Summary of Items Discussed in 2/2017 APSEC Discussion Forum on 17 March 2017

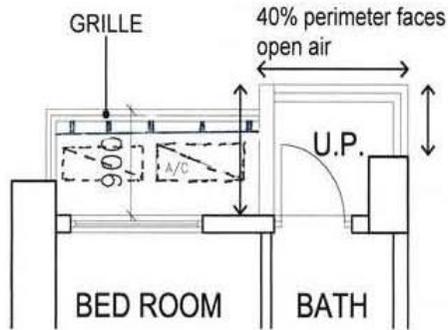
16.	<p><u>Protective Barrier at Window and Openable Area Calculation</u> (Item raised by AAP)</p> <p>It is our understanding that glass protective barrier in front of openable window can be ignored in the calculation of area required under B(P)R30(2)(a)(ii) as demonstrated in the diagrams below. Would BD confirm the same?</p>	<p>BD advised that while the glass protective barrier in front of the openable window would be considered as obstructing ventilation, protective barrier in form of well perforated metal grilles would usually be acceptable.</p>
